STAFF REPORT

TO: Development Contribution Levies – Delegated Committee
FROM: Dugald Ley, Development Engineer
REFERENCE: BC080647
SUBJECT: **C and L SALT - REPORT EP09/01/08** - Report prepared for hearing of 20 January 2009

C and L Salt, 137 Lodder Lane, Riwaka, application for a new dwelling and worker / visitor accommodation

SITE PLAN 1:500

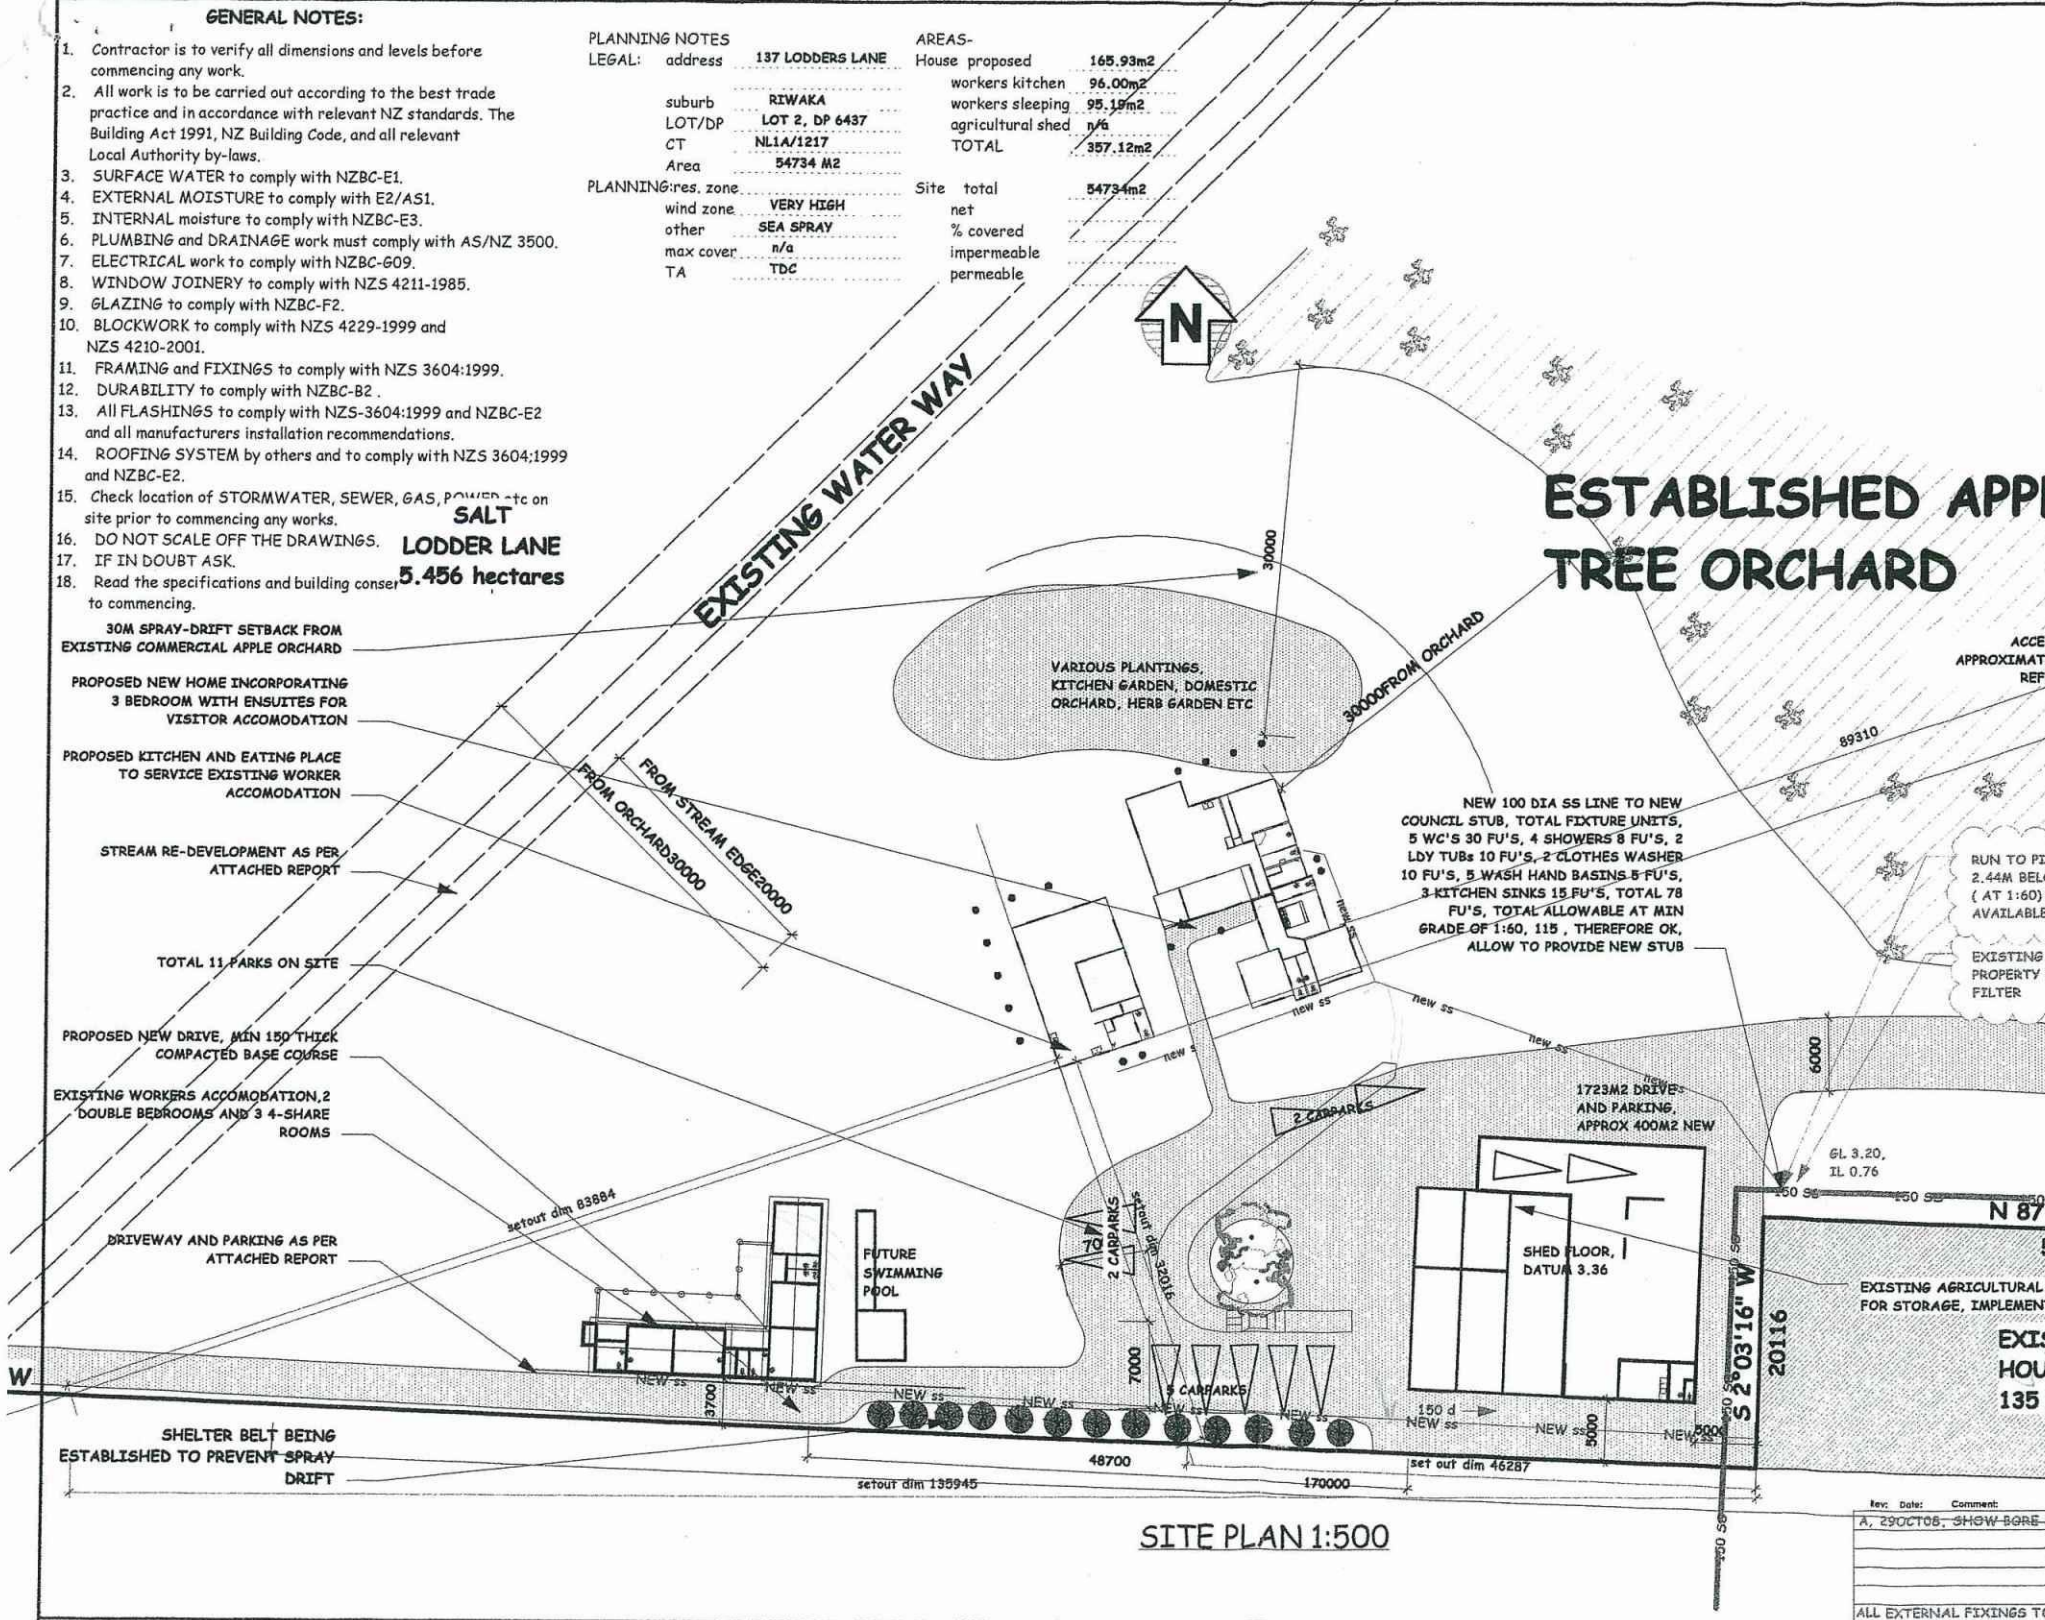
- a) Living/kitchen building - 95 m²
 - 12.0 m x 8.0 m building contains lounge, TV room dining, bathroom and one toilet.
- b) Dwelling/accommodation - 165 m²
 - Approximately 20.0 m x 14.0 m. Standard 1-bedroom dwelling.
 - Attached via a fire-rated door are three rooms each with an ensuite.
- c) Workers' accommodation – 95 m²
 - 14.0 m x 17.0m in an “L” shape
 - Five rooms – three with ensuites, two with shared ensuite.

- a) Living/kitchen building = 1 new pan
- b) Dwelling/accommodation = 4 new pans
- c) Worker accommodation = 2 new pans
- Total = 7 new pans

Reverting to the plan the dwelling/accommodation is made up of a 1-bedroom dwelling and attached via a fire rated separation door are three self-contained units.

Dwelling		= 2 car parks = 1 HUD
Three units		= 3 car parks
Workers Units	Room 1, 4 bed	= 2 car parks
	Room 2, 4 bed	= 2 car parks
	Room 3, 4 bed	= 2 car parks
	Room 4, 1 double bed	= 1 car park
	Room 5, 1 double bed	= 1 car park
Total car parks		13, less 3 for existing accommodation
		$\therefore 10 \div 3 = 3.33$
		$\therefore 3$ (rounded down)
